Construction Traffic Management Plan – Luddenham Road Gates 4&5

Western Sydney Airport – Surface and Civil Alignment Works

Project Name	Sydney Metro – Western Sydney Airport, Surface and Civil Alignment Works
Project Number	N81150
Revision Date	4 May 2023
Revision	05
Document Number	SMWSASCA-CPU-1NL-NL000-TF-PLN-000005

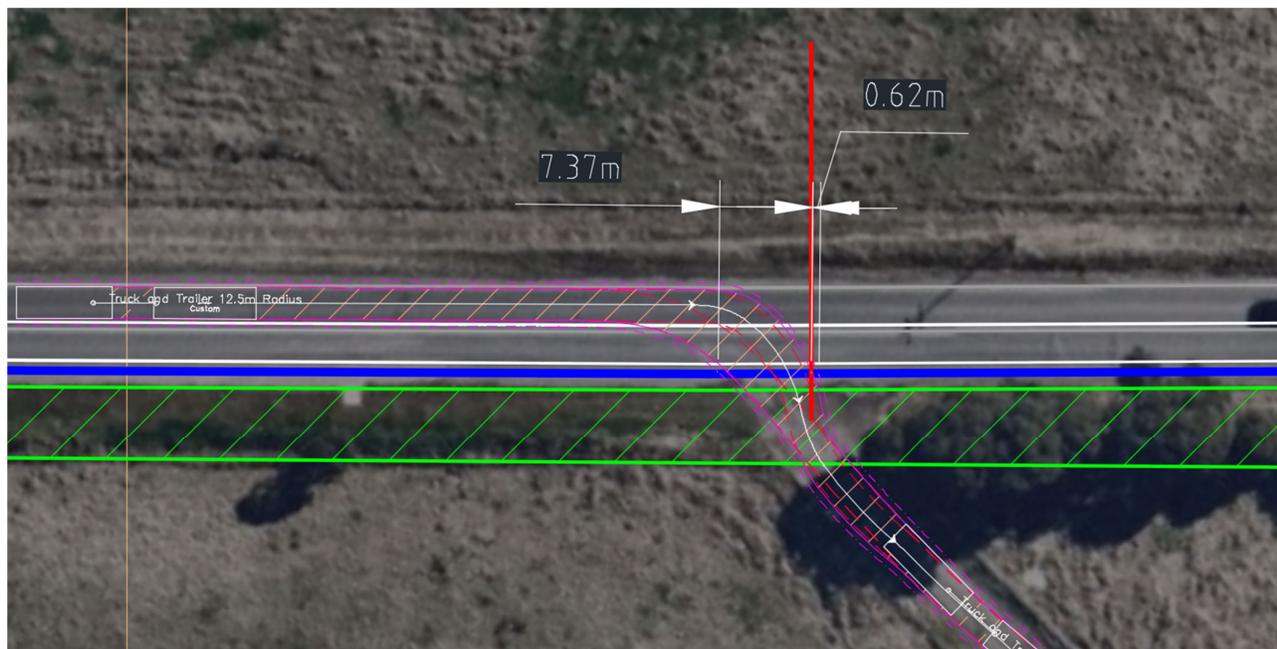
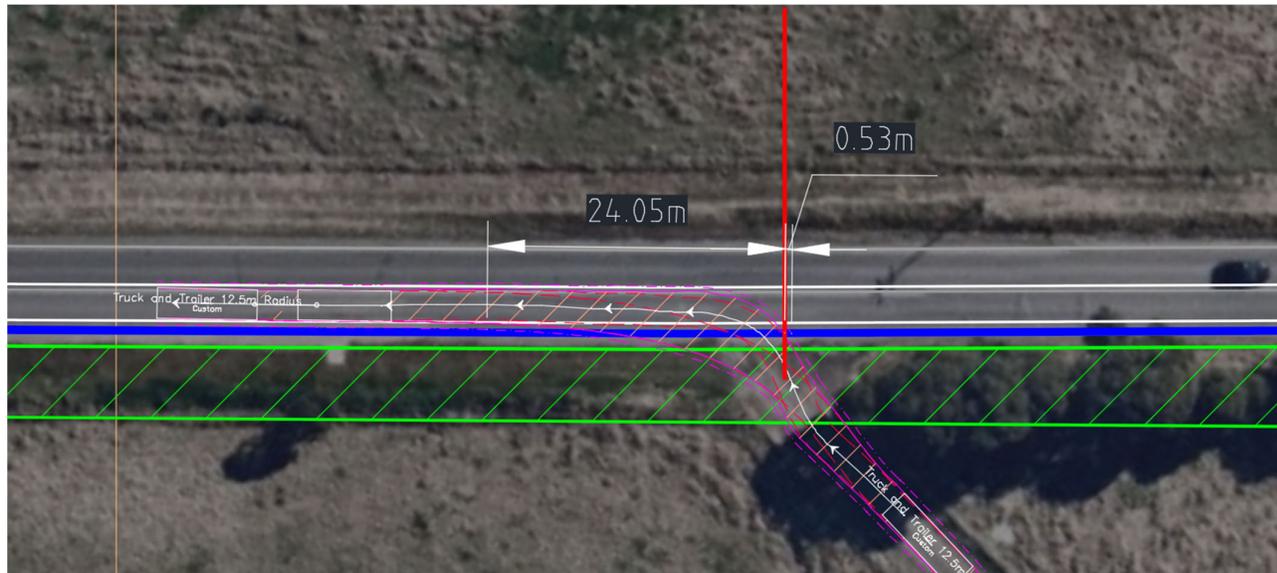
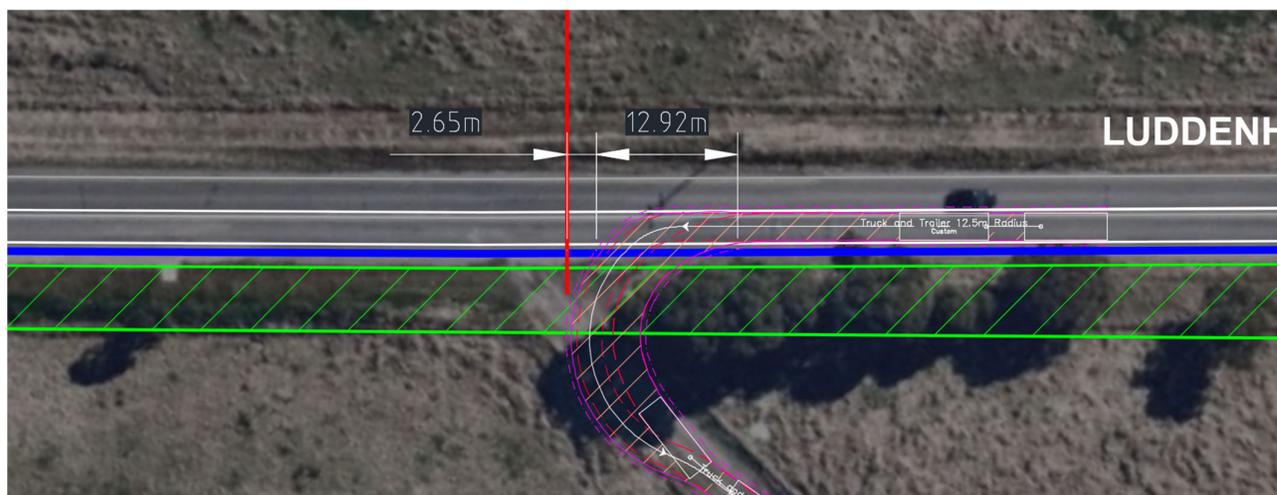
DOCUMENT NO.	TITLE	VER	STATUS	NO.	DATE	COMPANY	RAISED BY	REVIEW DOC. NO.*	DOCUMENT REF*	DEED REF*	COMMENTS / RESPONSE	COMMENT CATEGORY*	CLOSED OUT
				52	12/04/2023	TFN	[REDACTED]	MWSASCA-CPU-1NL NL000-TF-PLN- 000005	Appendix D Part 2 (pg.2)		Please advise the largest vehicle and if any turn restrictions apply on the driveway access between barriers/work zones.	Observation	N
								MWSASCA-CPU-1NL NL000-TF-PLN- 000005	Appendix D Part 2 (pg.2)		Refer to section 3.2 and 5 which clarifies vehicle size and access/ egress arrangements	Observation	N

52.01	17/04/2023	CPU	[REDACTED]	MWSASCA-CPU-1NL NL000-TF-PLN- 000005	Appendix D Part 2 (pg.2)		The access is an existing access point. Swept paths have been undertaken to show the vehicles that can access this location	Observation	N
								MWSASCA-CPU-1NL NL000-TF-PLN- 000005	Appendix D Part 2 (pg.2)			Observation	N

Comment 21.01.01

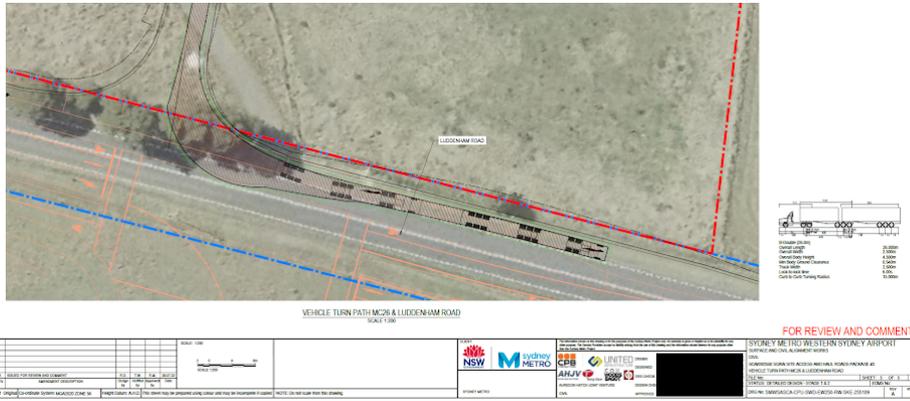
Egress movement for B-Doubles appears to extend into the marked bicycle path.

However, this path is not there at present and will be built by the developer at a later stage (> 2 years) and therefore would appreciate if the comment could be closed out
